Our Reference: P\_21\_19\_APP\_Mamre\_WAD\_DD

**Subject: Access Logistics Park – 884-928 Mamre Road, Kemps Creek – Access Road**

In regard to the email you sent on 16 February 2023 with subject "Access Logistics Park - Meeting Minutes for the 08.02.2023", we have outlined below our responses to the actions and comments made by TfNSW.

**Annexure 2 – Acceleration Design (Stage 2) 2021\_19\_SD\_0001\_SK00017 Issue A**

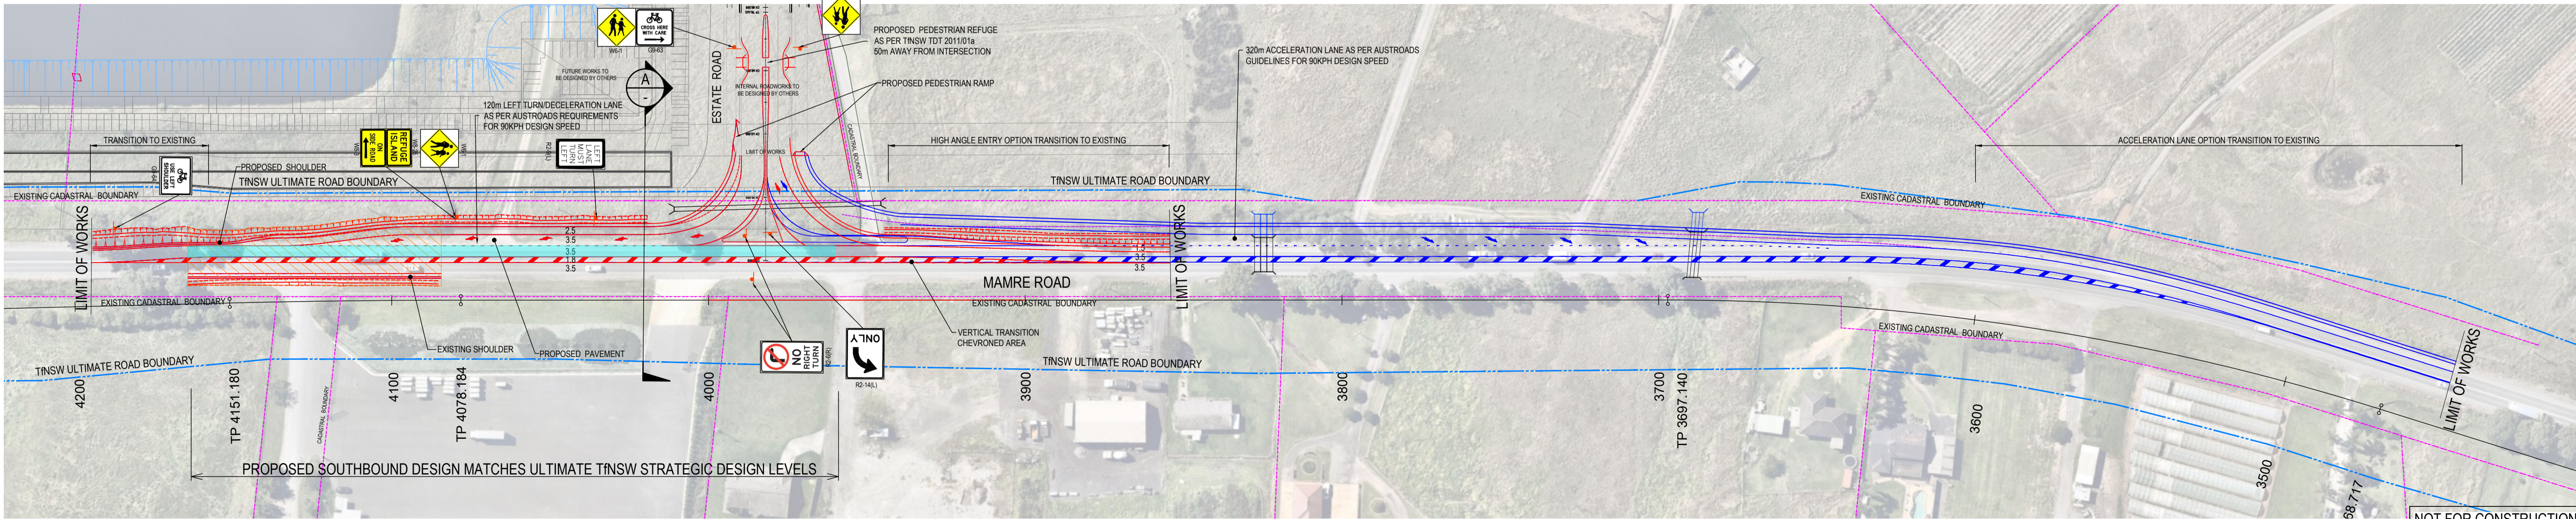
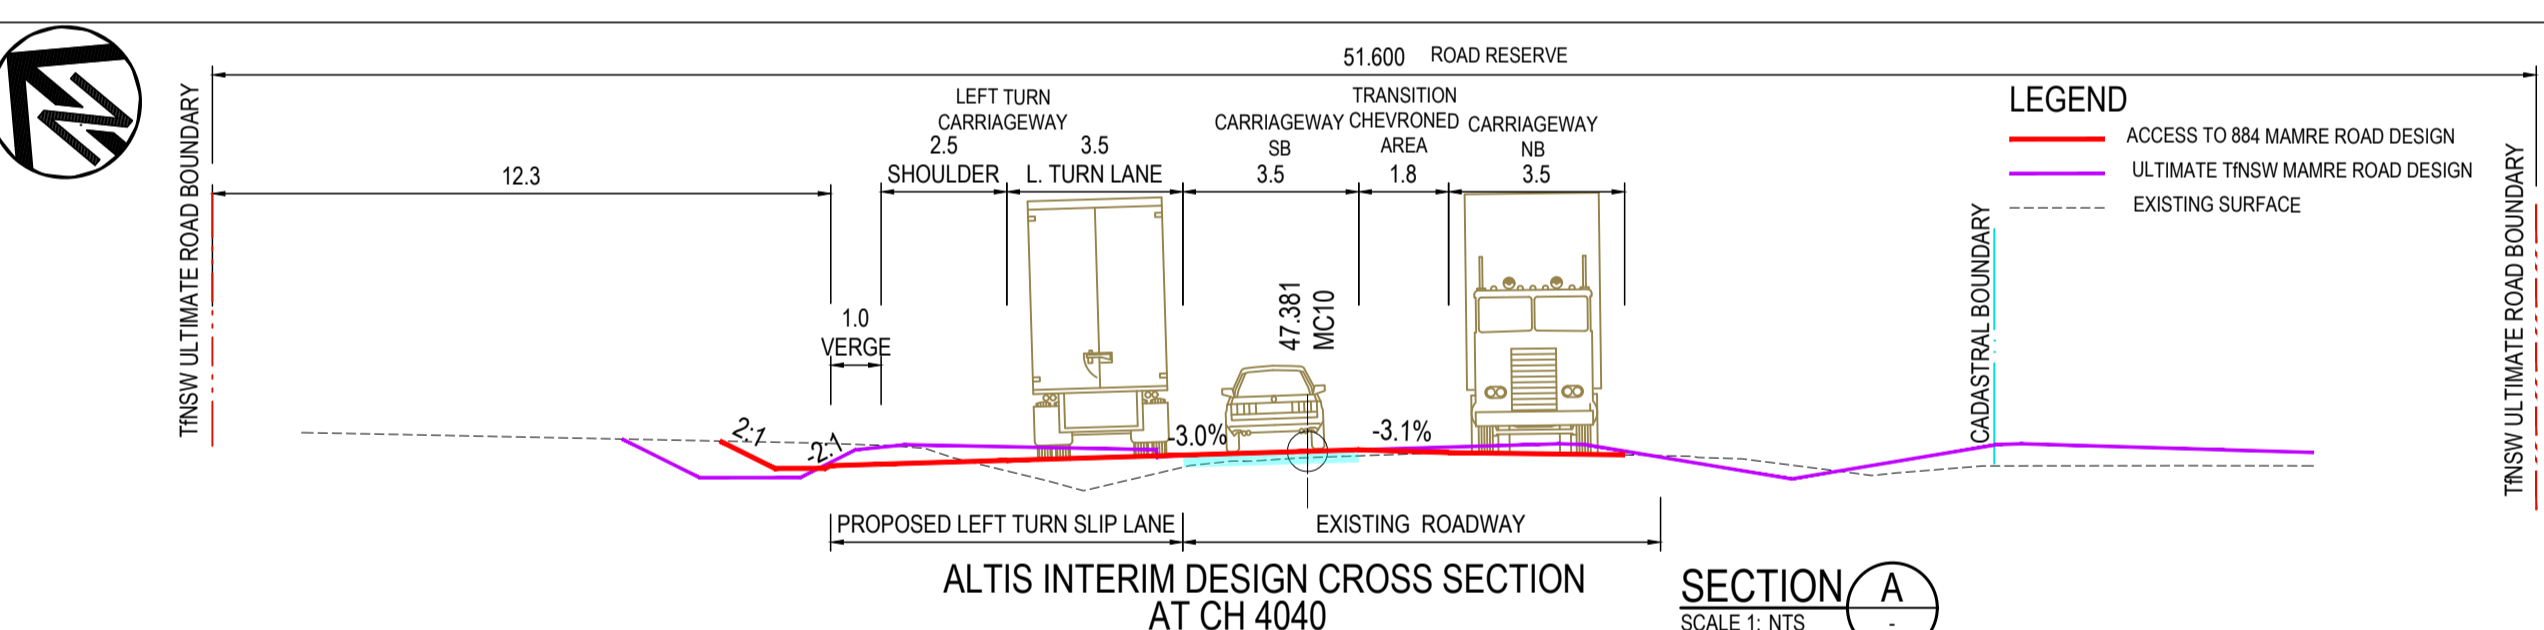
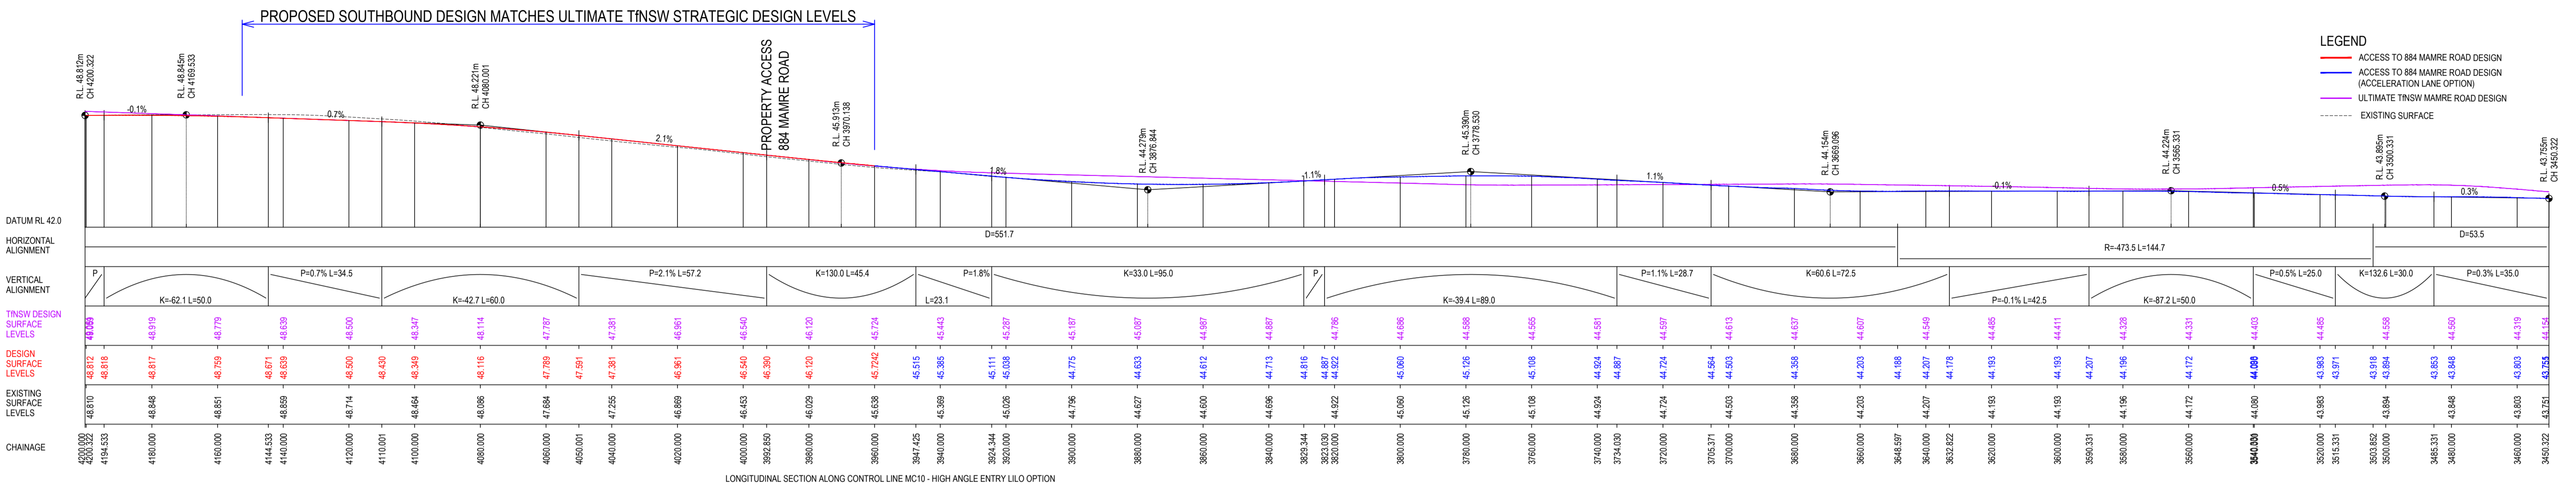
- b. TfNSW (JD) The retention of the existing driveway accesses with the 3m shoulder adjoining the deceleration lane extends across land that is not under the ownership of the Applicant or included within the current Development Application. As identified above the 3m shoulder and acceleration should be removed. Once the affected lots are developed TfNSW may consider the acceleration lane as a post development process.

Should TfNSW consider the acceleration lane as a post development process when the affected lots to the south are developed, the strategic design (2021\_19\_SD\_0001\_SK00017 Issue A) shows the extent of the acceleration lane that is compliant with Austroads guidelines for 90km/h design speed. This plan is contained in Annexure 2.

**Annexure 3 – Proposed LILO with TfNSW Ultimate Design Overlay  
2021\_19\_SD\_0001\_SK00018 Issue A**

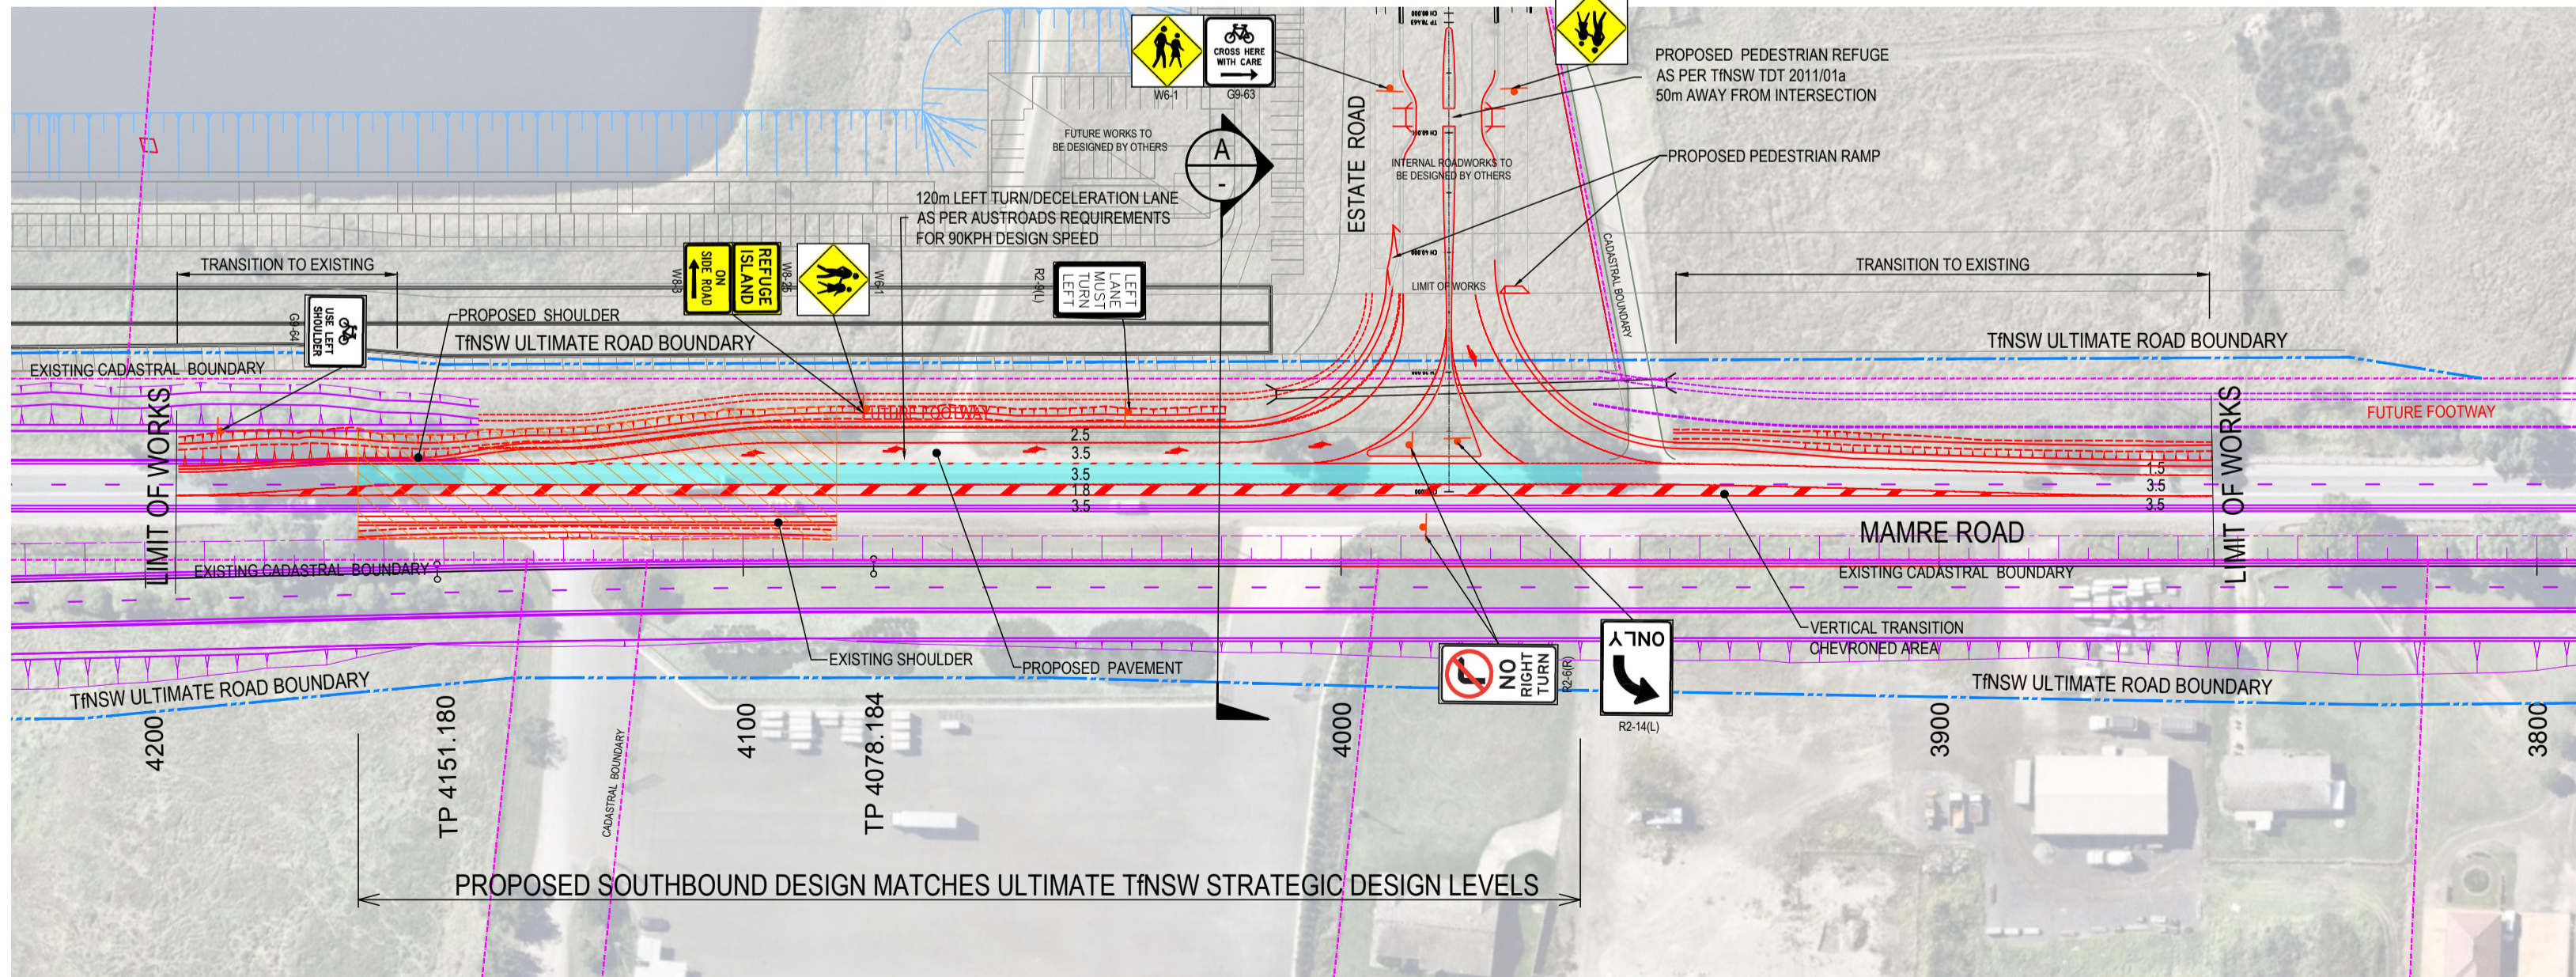
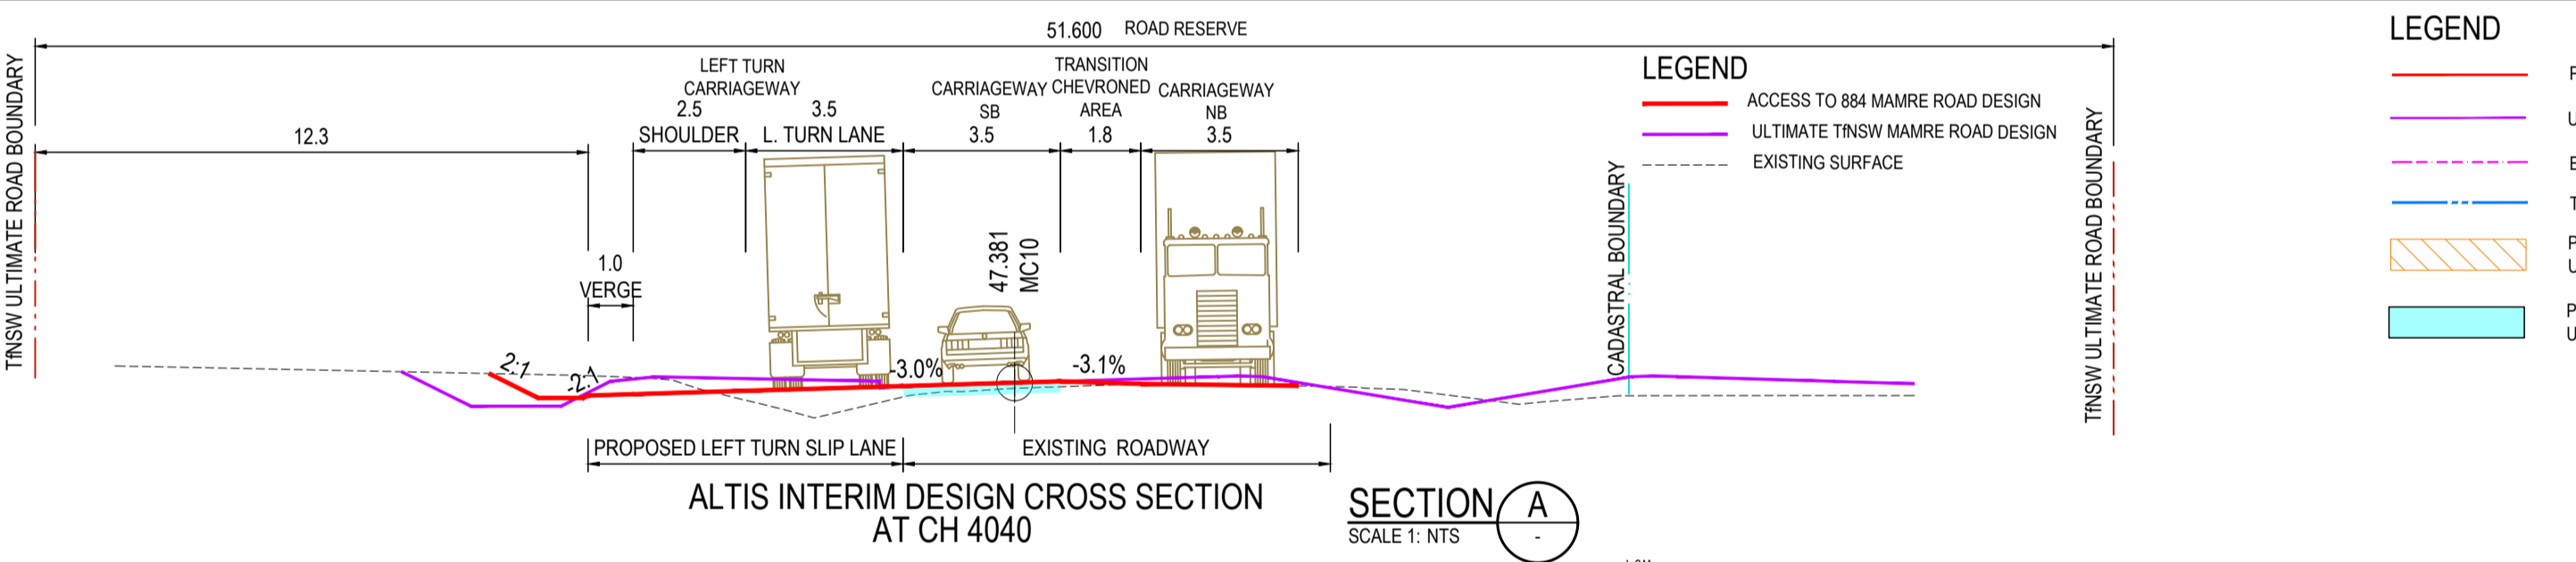
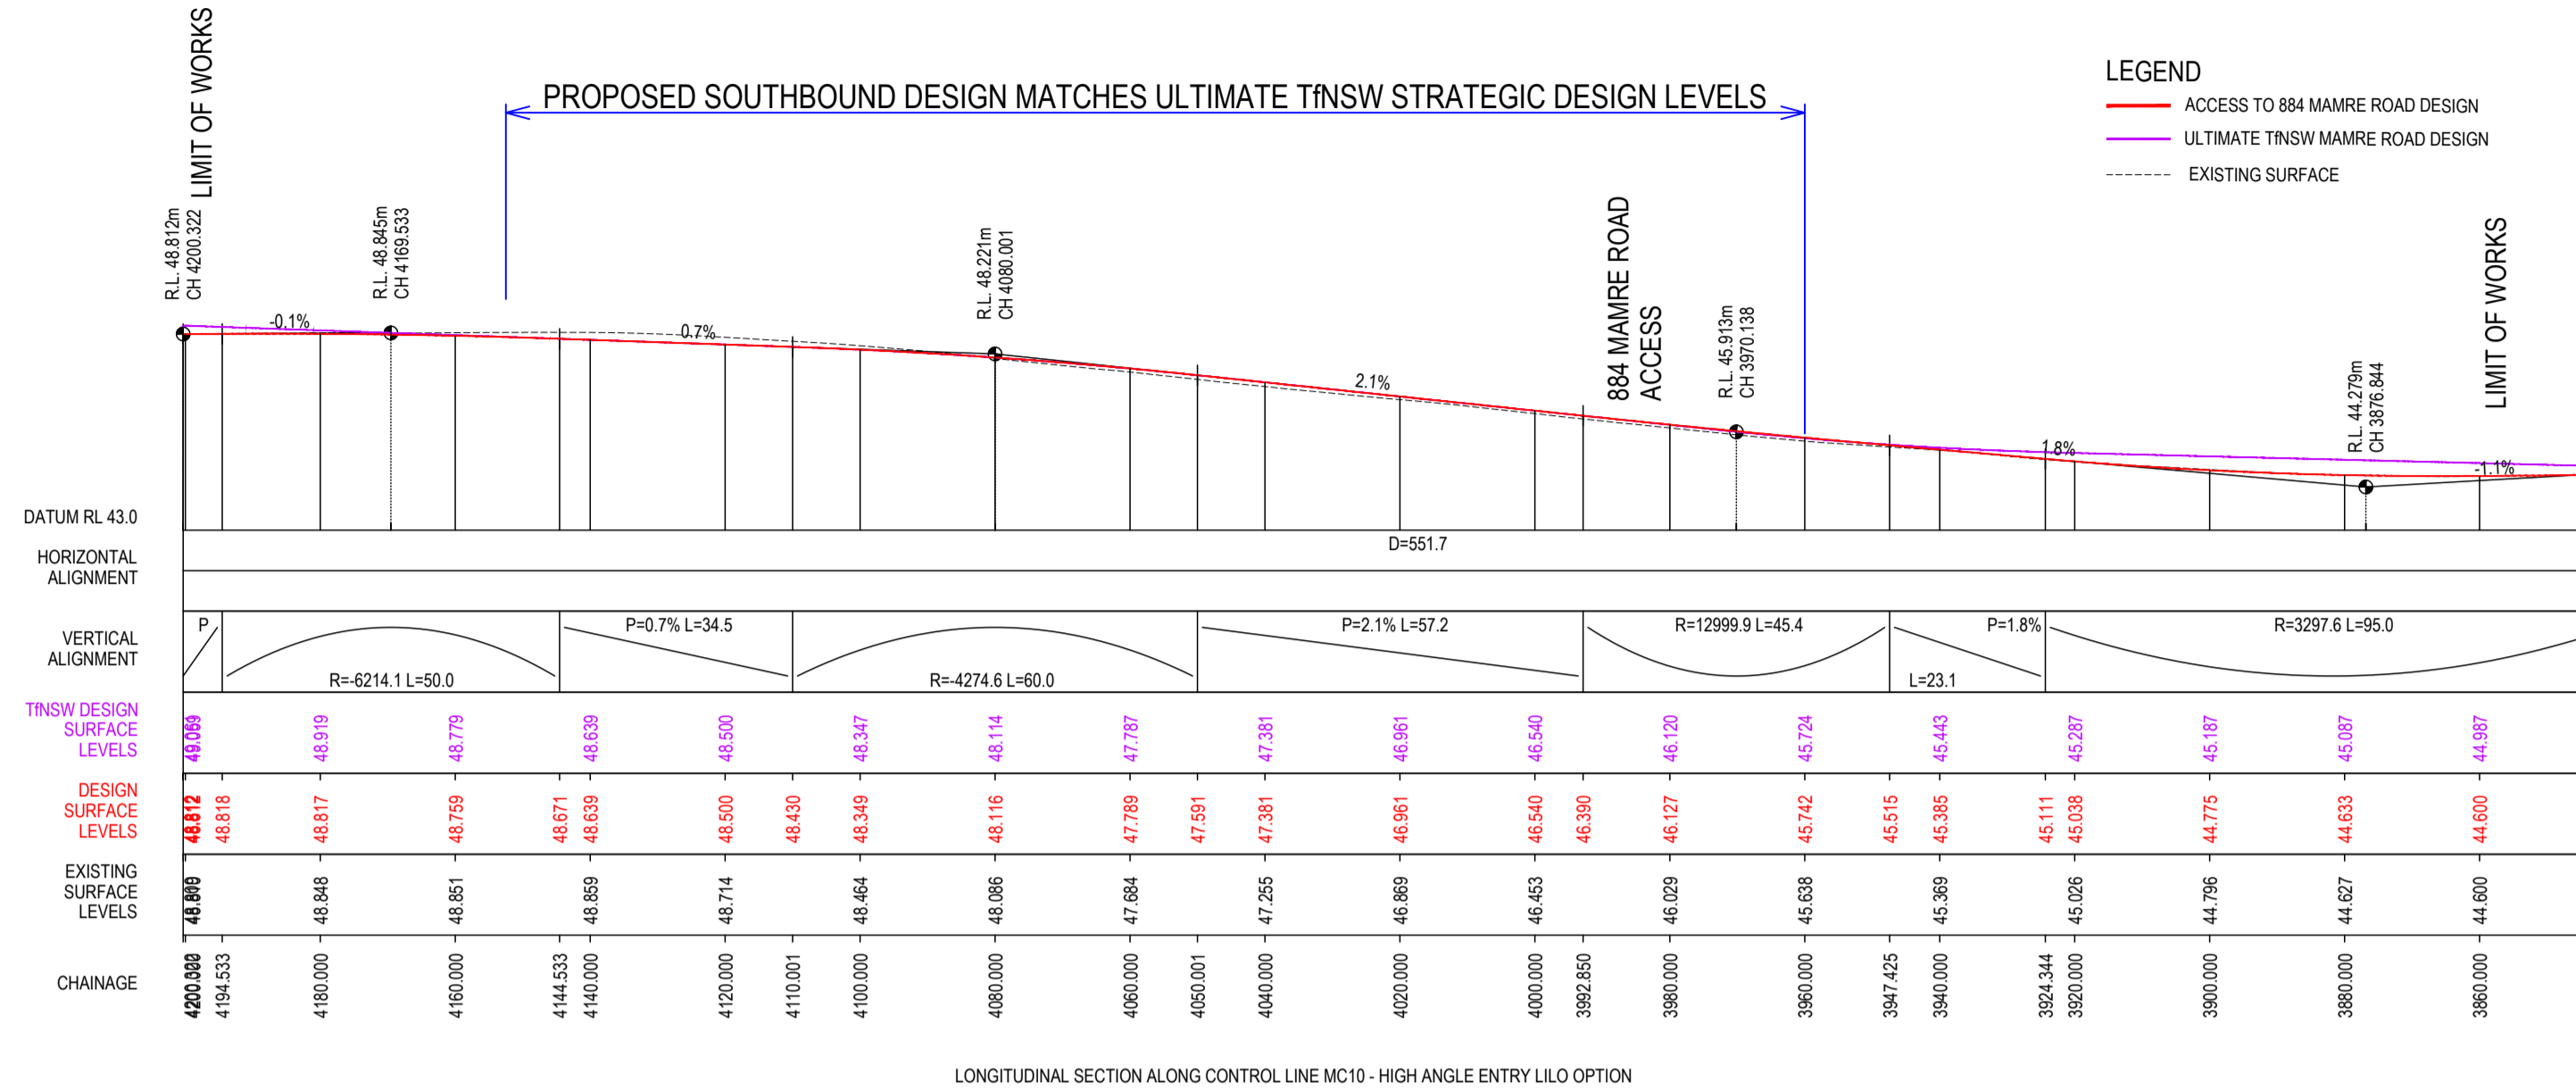
- d. Action (Applicant): The Applicant is advised that once the LILO has been amended to comply with the above a new set of revised plans, CAD Files (in the original format and displaying the Interim (if relevant) and ultimate design) and a long section of the deceleration lane should be provided to TfNSW for review.

The strategic design drawing (2021\_19\_SD\_0001\_SK00018 Issue A) is submitted to TfNSW in pdf and CAD format. The design displays the Interim arrangement (at opening of development), the TfNSW Ultimate Mamre Road design and a long section of the deceleration lane. This plan is contained in Annexure 3.
